**Addendum No. 3 to IFB 24-44**

**Henry Hansen Memorial Park Construction Services**

**Re:** Q & A, Clarifications in Response to City & Engineering Review, and Revised sheets L1.0, L2.0, L3.0,  
L4.0, L5.0, L7.0, L7.2, and L7.4.

3 RESET EXISTING MONUMENT STONE

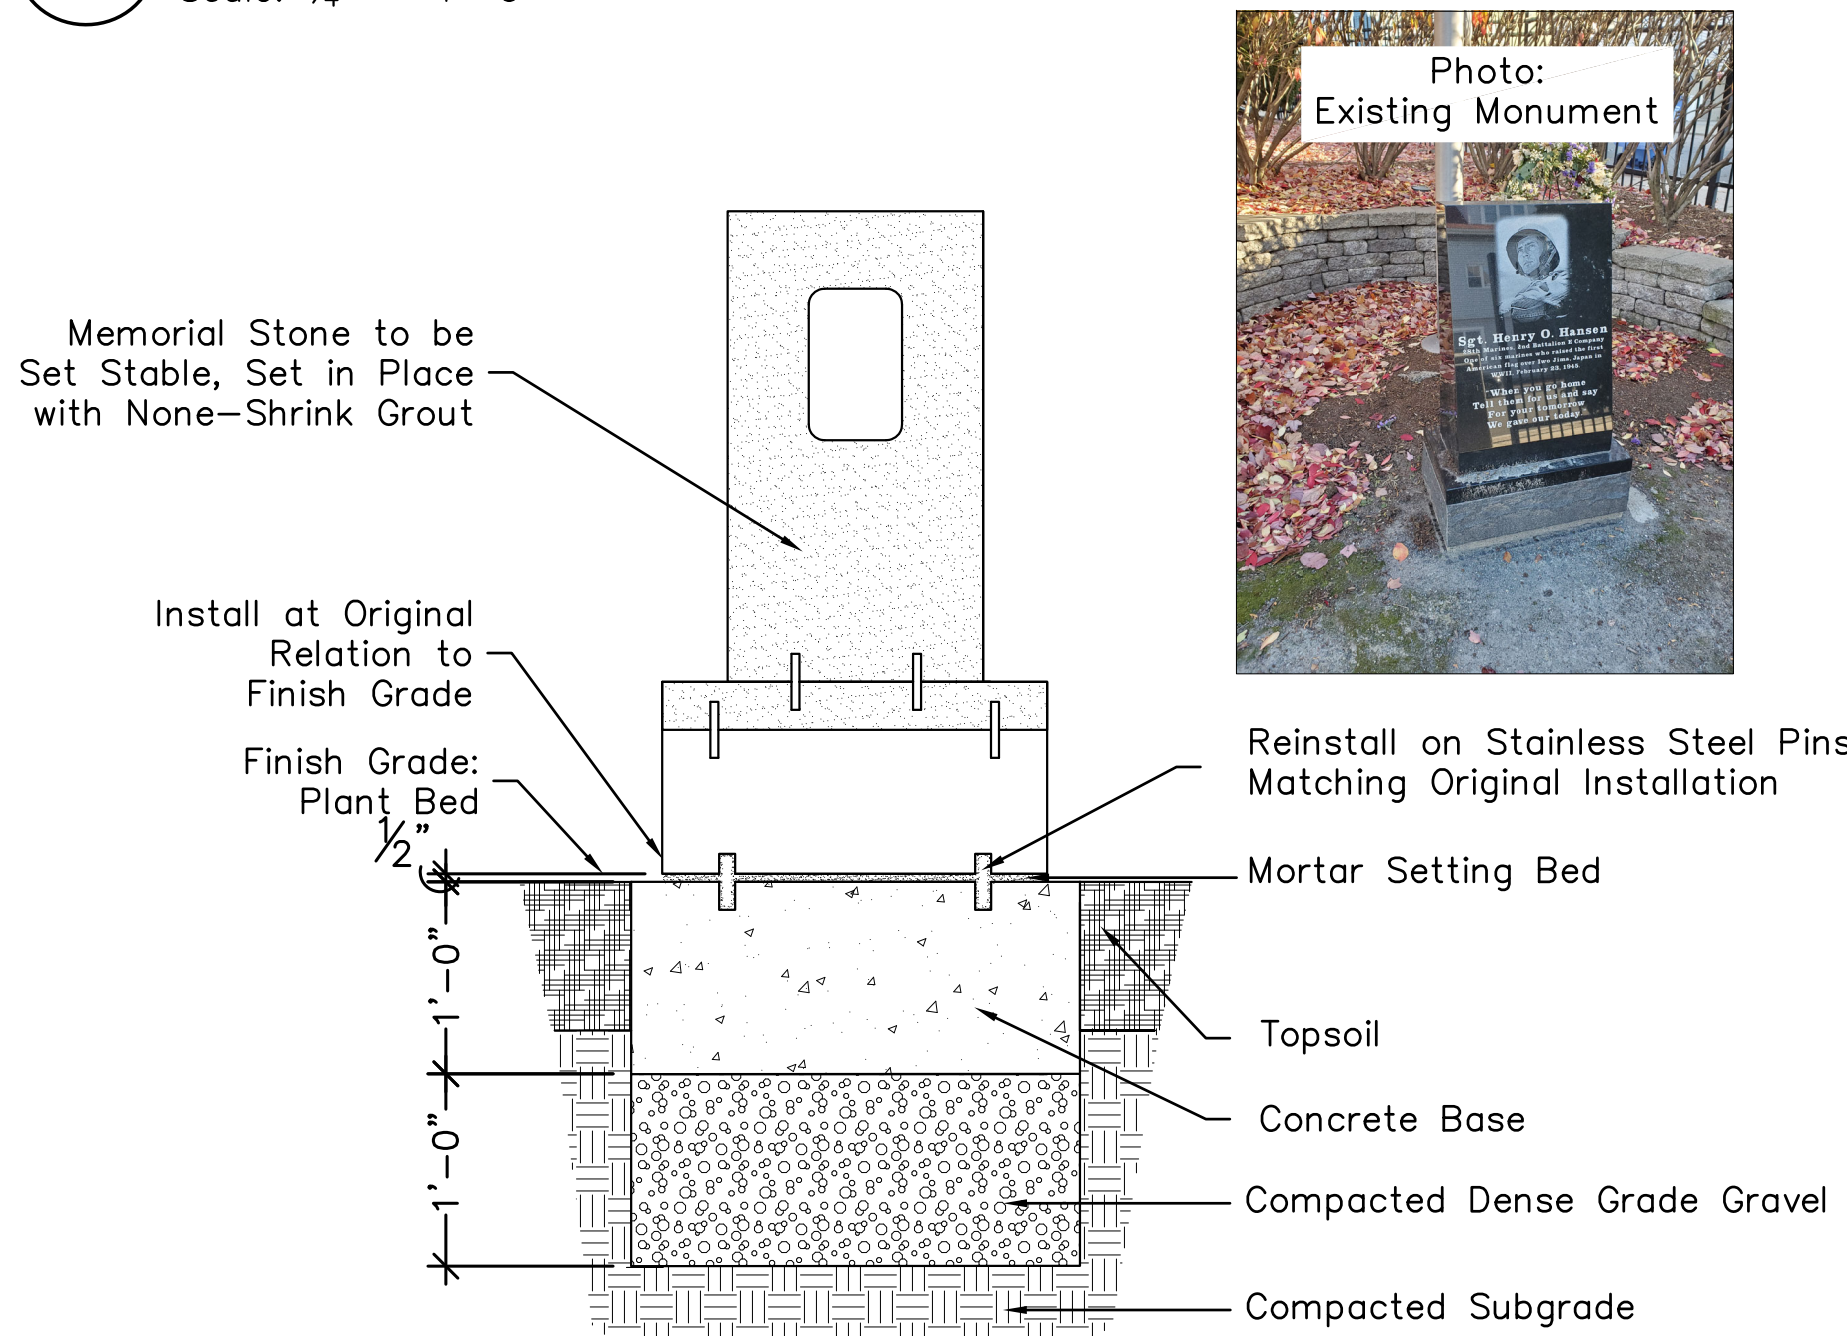
**Q2. How was the existing granite memorial stone installed?**

**A2.** The City is seeking clarification from the DPW, who installed the stone. Our working assumption (which bidders should assume for the purposes of bid preparation) is that the bottom granite piece is pinned with two (2) stainless steel pins, grouted in place, into the concrete footing below grade, and that the upper portion is similarly connected to the granite base by grouted stainless steel pins. The design team's recommendation is that the granite pieces of the monument itself not be separated from one another; only the connection to the concrete base below should be removed.

7 WATER SUPPLY LINE/DRAIN LINE  
Scale: 3/4" = 1'-0"

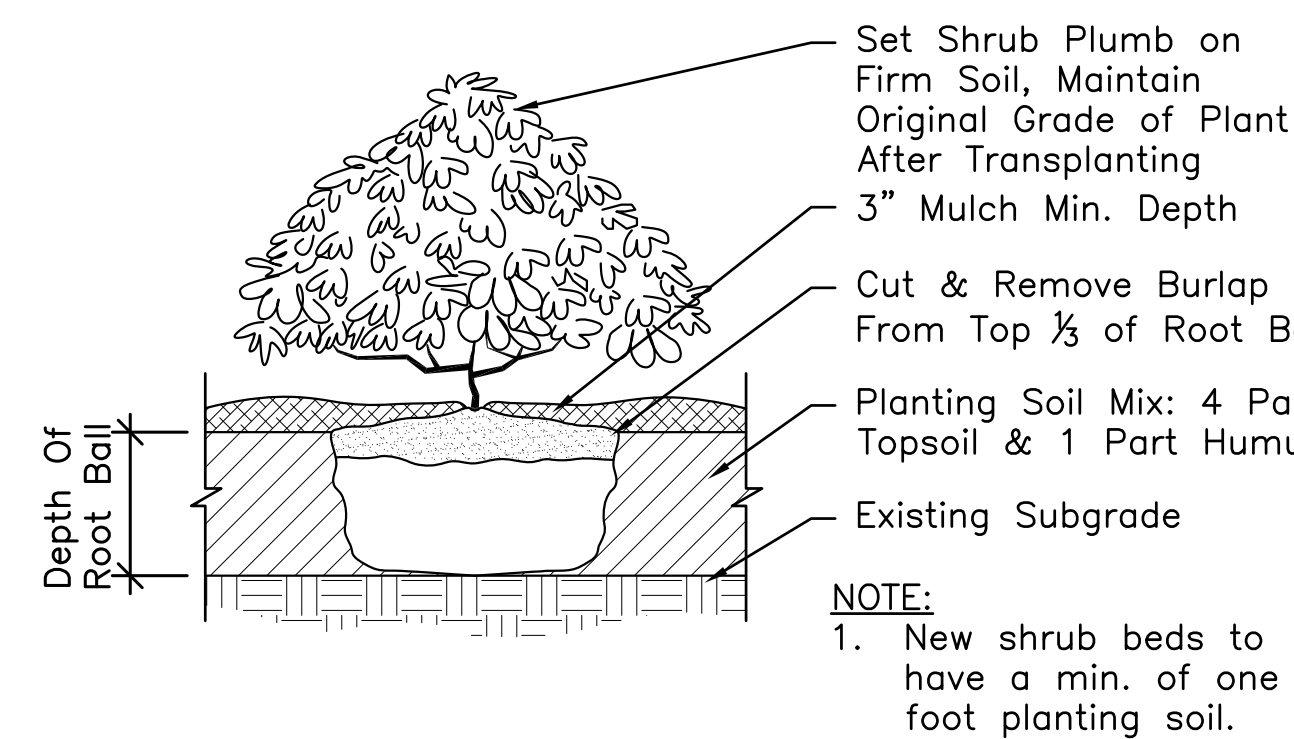
- 5.** The Engineering Department, as a permit condition, has required the removal of the connection to the existing street storm drainage system, and the replacement of the lower drain inlet with a leaching catch basin to which all other drainage in the park is connected. Sheets L1.0, L2.0 and L5.0 have been revised; accordingly, the drinking fountain detail 4/L7.2 has been revised to reflect the drain connection; and detail 10/L7.4 has been added for the Leaching Catch Basin.

9 DRAIN CLEANOUT  
Scale: 1 1/2" = 1'-0"

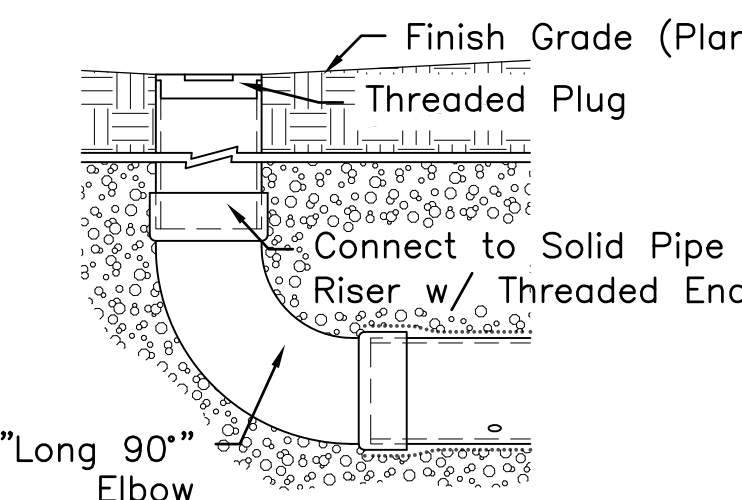
- 6.** Drain cleanouts have been added to the ends of the perforated footer drain for the retaining wall. The cleanouts are shown in the new detail 9/L7.4.

- NOTES:**
1. All pipe and fittings to be suitable for future cleaning with a "snake." Provide risers and caps where indicated on Utility Plan (L6.0).
  2. Caps to be a 4" Male NPT Flush Cleanout Plug (no vertical projection).
